**RE: *Item 10.2 – October 20, 2020 City Council Agenda:
C19-013, CP19-013 and T20-015 – Conforming Rezoning, Conditional Use Permit,
and Tentative Map for Certain Real Property Located at 550-570 Meridian Avenue,
1401 Parkmoor Avenue, and 529, 592, and 691 Race Street***

San Jose Vasona Quiet Zone Diagnostic Review Comments & Responses

DATE: August 6, 2019 (Day 1)

PARKMOOR AVE

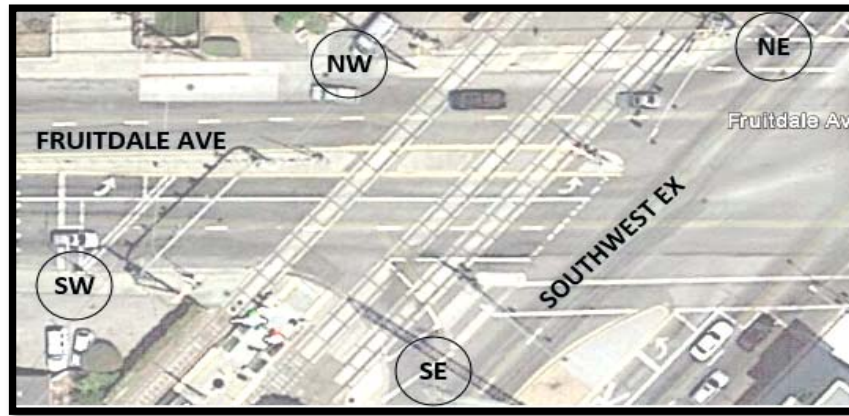
Comments		Response
<i>General</i>		
1	<p>Crash History 2007 - 2019:</p> <ul style="list-style-type: none"> •10/27/10 Injury: pedestrian suffered injuries when pedestrian ignored activated warning devices, went through gate in north quadrant and was struck by the LRT •2/23/13 Injury: bicyclist suffered injuries when bicyclist ignored activated warning devices, rode through pedestrian crossing in north quadrant, and was struck by the LRT •4/20/16 Injury: pedestrian suffered injuries when pedestrian ignored activated warning devices, went through gate in north quadrant, and was struck by the LRT •7/29/17 Fatality: eastbound bicyclist traveling in the westbound lanes ignored activated warning devices and was struck and killed by northbound LRT •3/23/18 Injury: pedestrian suffered injuries when pedestrian ignored activated warning devices, went through gate in north quadrant, and was struck by the LRT 	n/a - informational comment

2	Land Uses: office to the south; proposed school with 2700 students to the north	n/a - informational comment
3	Overall, FRA understands that there are efforts underway to improve the crossing (proposed improvements to be conditioned on school development, CSJ geometrics team evaluating intersection reconfiguration options), and requests CSJ engage FRA and CPUC in that ongoing work.	See Attachment L. This concept has been coordinated with FRA, VTA, and CPUC. The City will continue to coordinate the design with the stakeholders as it progresses.
4	Pedestrian treatments suggested at north quadrants especially; south quadrants don't appear to have enough ped traffic to warrant full treatments with automatic pedestrian gates.	See Attachment L for proposed gates. Pedestrian treatments at all quadrants are proposed.
<i>N quadrant</i>		
5	Pedestrians walking along the north side of Parkmoor Ave and crossing the tracks at Race St have a high rate of going around the pedestrian swing gates and refuge; consider shifting this crosswalk on the north leg of the intersection southerly to align with the pedestrian desire line and bring both tracks into the crosswalk signal at the northwest corner of the intersection	See Attachment L for the proposed improvements.

6	Can Sheriff or Police do more enforcement of violations?	County police perform regular sting operations at this location.
7	While diagnostic review was occurring, an individual in a wheelchair traveling southbound on Parkmoor across Race Street ignored crosswalk path and traveled parallel with the road. Suggest re-channeling pedestrians through this crosswalk.	See Attachment L for the proposed improvements.
<i>SE quadrant</i>		
8	Add Commission Standard #8 flasher to this quadrant as a near-side warning device for pedestrians approaching the crossing	See Attachment L for the proposed improvements.
9	Extend the chain link fence that runs along the rail corridor all the way to the back of sidewalk	This will be incorporated into the proposed improvements (Attachment L) as that design progresses.
10	Add a fence along the back of sidewalk between the intersection and the crossing to channelize pedestrians.	This will be considered with the proposed improvements (Attachment L).

<i>SW quadrant</i>		
11	Standardize signage	See proposed signage and striping plans in Attachment K.

FRUITDALE AVE

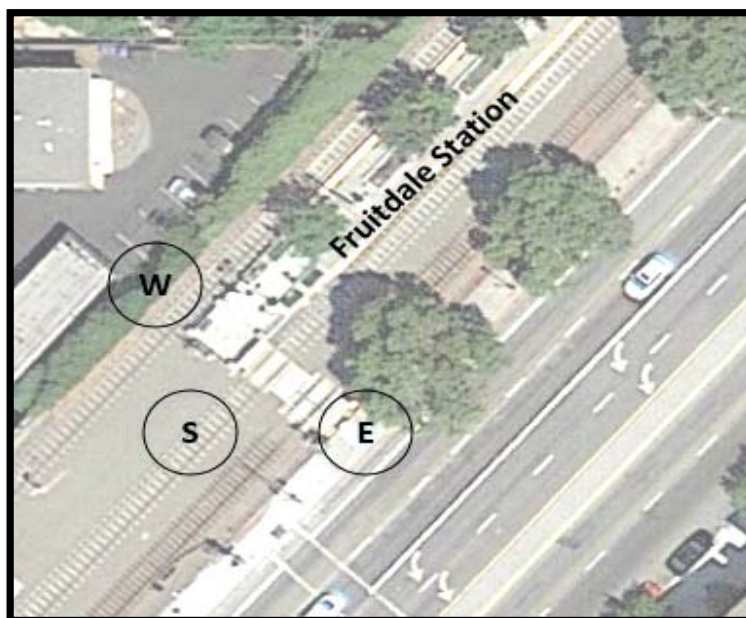
Comments		Response
<i>General</i>		
1	Crash History 2007 - 2019: •10/5/18 Injury: pedestrian suffered injuries when pedestrian ignored activated warning devices and was hit by LRT in quadrant	n/a - informational comment
2	Land Uses: multifamily residential all quadrants; LRT station to the south	n/a - informational comment
3	Lots of disabled and medical patients and emergency vehicles pass through this crossing from the Valley Medical Center one mile to the east	n/a - informational comment
4	Do crossings have power off indicators? VTA: they have live monitoring from OCC	n/a - informational comment
5	Dynamic Message Signs "No Right Turn" should be upgraded to the current R3-1 Activated Blank Out Sign standard with the next modification to this crossing's electrical devices	n/a - informational comment
6	There is an LRT station very close to this crossing; there is a pedestrian barricade along the median island to discourage jaywalking across Fruitdale; however there is no crosswalk on the west leg of the intersection; wonder if these conditions are encouraging pedestrians to cross Fruitdale by walking along the tracks (rather than using 3 crosswalks at the intersection); how can we improve it	See proposed signage and striping plans in Attachment K. A crosswalk on the west leg of Southwest Ex/Fruitdale Ave intersection could not be accommodated in the design and construction of the Vasona LRT corridor due to the proximity of the tracks to the intersection. While DOT does not recommend uncontrolled mid-block crosswalks across streets with 4 or more lanes, the pedestrian demand and non-compliance here triggered a more comprehensive analysis to provide a safe pedestrian crossing at this location. DOT will install a new enhanced crosswalk with bulb-outs, median refuge island, and rectangular rapid flashing beacons on Fruitdale Ave at College Dr, approximately 460 feet west of the tracks, to be implemented in 2020.

7	<p>While diagnostic review was being conducted a truck and 2 cars became stuck between activated arm gates and intersection at both the Southeast and Northeast quadrants indicating the timing of the signals needs to be adjusted to allow vehicles to adequately clear the area</p>	<p>Track Clearance timing doesn't start after the gates are down, but before that, in order to let the vehicle to pass and clear the intersection. During the diagnostic review at this intersection, the timing settings for preemption events were checked and were found to be adequate. The preemption log was shown to FRA and CPUC representatives.</p> <p>Also, see proposed signage and striping plans in Attachment K. For the eastbound movement, the pre-signal stop bar will be relocated, the downstream stop bar eliminated, and Keep Clear pavement markings added at the tracks. These striping changes should reduce the amount of eastbound drivers crossing the tracks after the pre-signal turns red and track clearance is underway.</p>

8	<p>While diagnostic review was occurring, members of the team became caught between the light and the gate arm at the northwest and northeast quadrants indicating the timing of the signals needs to be adjusted to allow pedestrians to clear the area</p>	<p>The crossing across the rail tracks is not signalized, therefore the pedestrian crosswalk timing on the north leg of the intersection does not include time to cross the tracks. We acknowledge that the pedestrian storage space at this corner between the gate arm and the curb is limited. Further, there is no crosswalk on the west leg of the signalized intersection. To accommodate pedestrian movements across Fruitdale, DOT will install a new crosswalk on Fruitdale Ave, approximately 460 feet west of the tracks. This will serve pedestrians between the residential neighborhoods to the north and the LRT station to the south. By using this crosswalk, most pedestrians will not need to travel through the northwest corner of the signalized intersection where the storage space is limited.</p>

<i>SE quadrant</i>		
9	<p>EB Fruitdale drivers tend to violate the pre-signal; adjust the louvers on the far-side traffic signal heads so that upstream drivers don't see the green light until they pass the pre-signal</p>	<p>See proposed signage and striping plans in Attachment K. The stop bar will be relocated and signal heads will be evaluated.</p>
10	<p>Check track clearance green time for EB Fruitdale is set correctly in traffic signal controller</p>	<p>See Fruitdale Comment Response #7.</p>
11	<p>refresh paint for edge lines that line the crossing over the tracks</p>	<p>Comment for VTA.</p>
12	<p>Fruitdale EB right is high speed and has low visibility with pedestrians at the corner or pork chop; crosswalk between the corner and the pork chop is also problematic because it leads pedestrians into the tracks without any other protection or warning devices besides a detectable warning strip; suggest reconfiguring the geometry, e.g. bring the curb out into the roadway to expand the ped refuge on the sidewalk, cut the pork chop island back, and add full pedestrian treatments with Commission Standard 9 pedestrian gates, EXIT swing gates, and channelization on the sidewalk</p>	<p>See proposed signage and striping plans in Attachment K. Eastbound right turn edge line striping will be shifted to narrow the lane, slowing down traffic, and making the vehicle lane meet the crosswalk closer to a 90-degree angle rather than a sweeping curve. Raised pavement markers are added on the edge striping to emphasize this effect. The existing No Turn On Red sign at the pre-signal is replaced with the graphical equivalent, R13A (CA). The placement of the Stop Here on Red sign is corrected to be below the R13A (CA) instead of above.</p>

13	There is a streetlight in the sidewalk that is blocked by the tree	Trees have been trimmed.
<i>NE quadrant</i>		
14	W10-4 is blocked by trees; trim trees	Trees have been trimmed.
15	Pedestrian refuge in the sidewalk is extremely small; very little space for even one person to wait while gate is down	See Fruitdale Comment Response #8.
16	Refresh pavement striping	See proposed signage and striping plans in Attachment K.
17	Southbound right turn queue backs up in the peak and drivers often violate the "No Right Turn" sign which is activated with the crossing devices	There is a vehicle gate arm and median island that prevent drivers from circumventing the gate arm.
<i>NW quadrant</i>		
18	Driveway closest to the crossing should be striped as a right turn out only; add edge lines in the driveway to guide vehicles to turn right out, and physically modify the driveway to force vehicles to turn right as they exit	See proposed signage and striping plans in Attachment K. A Right Turn Only sign for the westerly driveway will be added. The westerly driveway cannot be physically modified to force a right turn out because it is also used as an entrance driveway for vehicles turning right in.

19	This pedestrian gate is an old design; if upgraded, the new design should include a swing gate next to the automatic gate and channelization	n/a - informational comment
20	Warning signs are located very close to the sidewalk, partially obstruct sidewalk path	See proposed signage and striping plans in Attachment K. The R15-8 sign will be removed.
<i>SW quadrant</i>		
21	Change "No Train Horn" sign located under the W10-1 to standard dimension	See proposed signage and striping plans in Attachment K. This sign will be replaced.
22	Refresh pavement markings on EB Fruitdale	See proposed signage and striping plans in Attachment K.
23	"No Train Horn" and "Look Both Ways" warning signs mounted on sound wall are covered by ivy; relocate to pole mount	See proposed signage and striping plans in Attachment K. These signs will be relocated.

LEIGH AVE

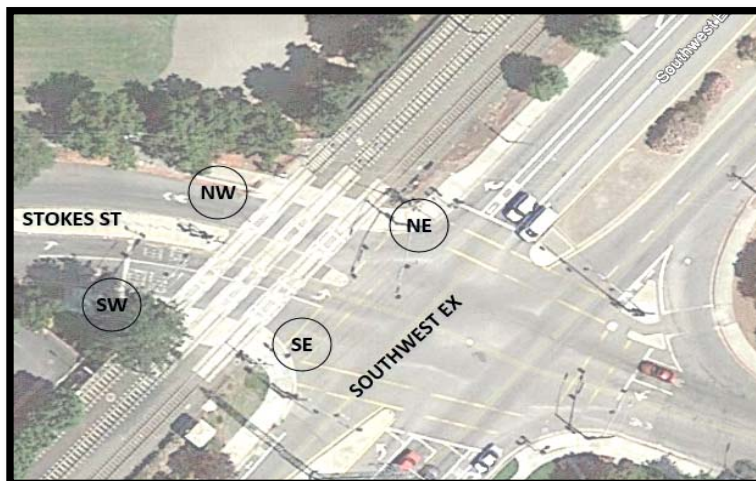
Comments		Response
<i>General</i>		
1	Crash History 2007 - 2019: o 6/18/09 Fatality: pedestrian ignored activated warning devices, went around vehicular gate arm and was struck and killed by LRT o 1/2/11 Fatality: pedestrian ignored activated warning devices, ran across the tracks and was hit and killed by LRT	n/a - informational comment
2	Land Uses: residential, gas station, proposed commercial and senior housing	n/a - informational comment
3	This crossing is ideal for a 4-quadrant gate system because of the number of fatalities, the intersection with Cheney Dr very close to the crossing negating raised concrete median, and the high amount of traffic. The only location an exit gate could be installed in the NW quadrant is on the north median	This quiet zone application proposes a partial risk reduction for the ASM at this crossing due to Cheney Dr intersection. Vehicle exit gates were prioritized at other locations on the corridor.

<i>SW quadrant (where Cheney intersects Leigh)</i>		
4	On Cheney Dr, update W10-9P and place under W10-4; add W48 CA (3 Tracks) under W10-4; rotate W10-4 (Immediate action item)	See proposed signage and striping plans in Attachment K. These changes are reflected.
5	Remove W10-1 (since W10-4 is the appropriate sign here) (Immediate action item)	See proposed signage and striping plans in Attachment K. This sign will be removed.
6	Update W10-9Ps mounted on streetlight poles at crossing and at RXR pavement marking to standard size	See proposed signage and striping plans in Attachment K. These changes are reflected.

7	Check striping; stop bar at Cheney Dr should be intersection type; also need crosswalks at Cheney	See proposed signage and striping plans in Attachment K. Cheney Dr is converted from Yield to Stop control; the triangle island is removed; the south corner is bulbed out; a crosswalk is added across Cheney.
8	The automated pedestrian gate is mounted on the same pole as the vehicle gate; this is no longer allowed because if someone were to lift up one gate, the other gate would also lift up; this would have to be upgraded to the current standard if this crossing's electrical devices were modified	n/a - informational comment
9	There are advance warning signs (Look both Ways, No Train Horn, Look) mounted on a pole inside the crossing; relocate to be in advance of the crossing so they can warn users in advance; consider mounting on pedestrian swing gate	See proposed signage and striping plans in Attachment K. These signs will be relocated.

<i>SE quadrant</i>		
10	Check warning sign sizes	The R15-8 sign will be removed. The W82-1(CA) and W10-9P signs conform to CA MUTCD size requirements.
11	Ideally this quadrant would have the same pedestrian treatments as those on the other side of the tracks (Commission Standard #9 pedestrian gate EXIT, swing gate, channelization)	VTa plans to install pedestrian gates on this quadrant as part of the "Pedestrian Back Gates" project. This work will include relocation of the detectable warning strips.
12	Check that the detectable warning strip is a safe enough distance from the UPRR track	See Leigh Comment Response #11.
13	If this crossing's electrical system was modified, the "No Right Turn" dynamic display sign would need to be updated to the current R3-1 Activated Blank Out Sign standard	n/a - informational comment
14	Signs are not compliant with GO 26-D clearance requirements. Signs need to be relocated	See proposed signage and striping plans in Attachment K. These signs will be relocated.

<i>NE quadrant</i>		
15	If this crossing's electrical system was modified, the "No Right Turn" dynamic display sign would need to be updated to the current R3-1 Activated Blank Out Sign standard	n/a - informational comment
16	Check the pedestrian signal at the north end of the crosswalk across Leigh; the countdown did not appear with one of the pedestrian phases (immediate action item)	This occurred because the Ped Walk and Ped Clearance phases are terminated when preemption is initiated per CA MUTCD standard 4D.27.29. The pedestrian phase returns to normal in the next cycle after the train has cleared.
17	Consolidate the W10-9P and W10-4 signs; add a W48(CA) sign	See proposed signage and striping plans in Attachment K. These signs will be consolidated.
18	For clearance, relocate the advance warning signs which are currently located between the UP track and the gate arm	See proposed signage and striping plans in Attachment K. These signs will be relocated.

19	Ideally there would be better pedestrian accommodation, including a wider refuge area here, pedestrian gates, and a wider paved area crossing the tracks. Requires major reconfiguration including relocating Commission Standard #9 pedestrian gate, install EXIT swing gates, install channelization behind relocated #9 vehicular gate.	With VTA's Pedestrian Back Gates project, this crossing will have pedestrian treatments on three out of four quadrants. This would be the only remaining quadrant without pedestrian treatment. The vehicle gate currently encompasses the entire sidewalk. Relocating the vehicle gate and/or adding pedestrian treatments was not prioritized at this location.
<i>NW quadrant</i>		
20	For southbound (or westbound) Leigh, adjust far-side louvers so that drivers at the pre-signal cannot see the green light at the downstream signal	See proposed signage and striping plans in Attachment K. The stop bar will be relocated and signal heads will be evaluated.

21	Signal box blocks visibility between trains and sidewalk; ideally it would not have been placed here	The general comment that signal box location is important as it relates to visibility between the crossing and the rail corridor is noted and will be considered in design of new crossings and redesign of existing crossings.
22	There is a space between the signal box and the fence behind it; shrubbery obstructs view of it; this space should be maintained and monitored to prevent criminal activity or tampering with the crossing	Comment for VTA.
23	Trim the tree behind the signal box	Comment for VTA.
24	There is a No Trespassing sign on the fence behind the signal box; trim the foliage blocking the sign and also consider relocating the sign	Comment for VTA.
25	Remove the non-compliant No Train Horn sign and pole; there is already a (compliant) No Train Horn sign within 10 feet of it	See proposed signage and striping plans in Attachment K. This sign will be removed.

26	Relocate the bus stop which is located about 90 feet west of the crossing; stopped buses can cause vehicles to queue over the tracks	VTA removed this bus line in December 2019 as part of a new transit service place.

BASCOM STATION-NORTH & BASCOM STATION-SOUTH

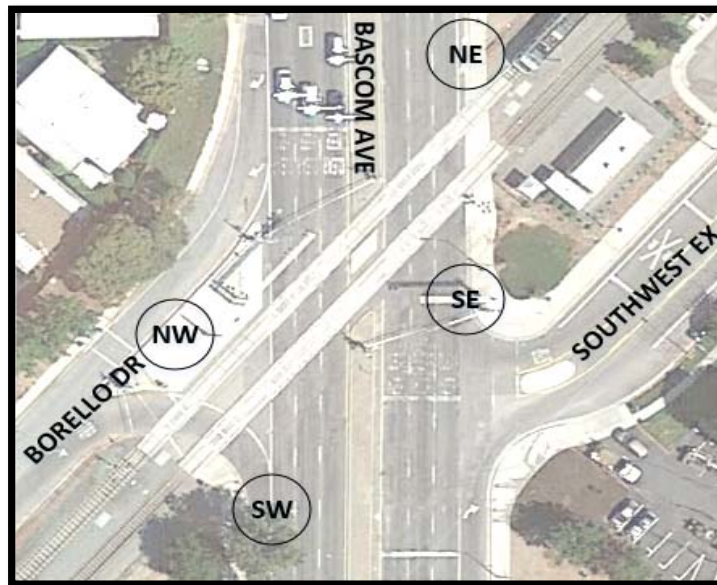
Comments		Response
<i>General</i>		
1	Crash History 2007 - 2019: none	n/a - informational comment
2	Land Uses: multifamily residential; development proposed on the triangular parcel to the northwest of Bascom LRT Station will provide pedestrian access to both station entrances; the development includes 600 residential units, 300,000 square feet of commercial space, and a 200,000 square feet office building	n/a - informational comment
3	CPUC submitted a comment letter to City of San Jose Planning on 8/5 in which it recommended that the proposed development on the northwest quadrant: o Install Commission Standard 9 pedestrian automatic gates with EXIT swing gates and channelization at both pedestrian station crossings. o Relocate the detectable warning strips outside of the swing gates at the two pedestrian station crossings.	The developer must provide direct access to one or both station platforms from the development site per the City's permit conditions. The developer, City, and VTA have been in close coordination for two years, and the developer understands that they need to work with VTA and CPUC to modify the station crossing(s). The developer scheduled a field diagnostic with CPUC, VTA, and the City on 1/17/20.

4	Consider standard sign set up at all station crossings; perhaps move "Look Both Ways" and "No Train Horn" signs to swing gates	City is currently coordinating signage and striping plans with VTA.
5	Crossbuck signs on posts need to be rotated to face pedestrians coming from outside the crossing- rotate or add another crossbuck sign facing the nearest approach	Comment for VTA.
6	Replace signs damaged with graffiti (immediate action item)	Comment for VTA.
7	Swing gates need maintenance (immediate action item)	Comment for VTA.
8	Striping across tracks to delineate edge of pedestrian path needs to be refreshed	Comment for VTA.
9	Relocate detectable warning strips to outside of crossing	Comment for VTA.

10	Future development on the west side of the rail corridor will need a Commission Standard #8 flasher on west side of tracks	See Bascom Stations Comment #3.
----	--	---------------------------------

11	Blue ENS should be relocated to the post with the crossbucks as is typical at other ped crossings	Comment for VTA.
----	---	------------------

12	There is a "Look Both Ways" sign in between the tracks; consider removing, or relocate to swing gate	Comment for VTA.
----	--	------------------
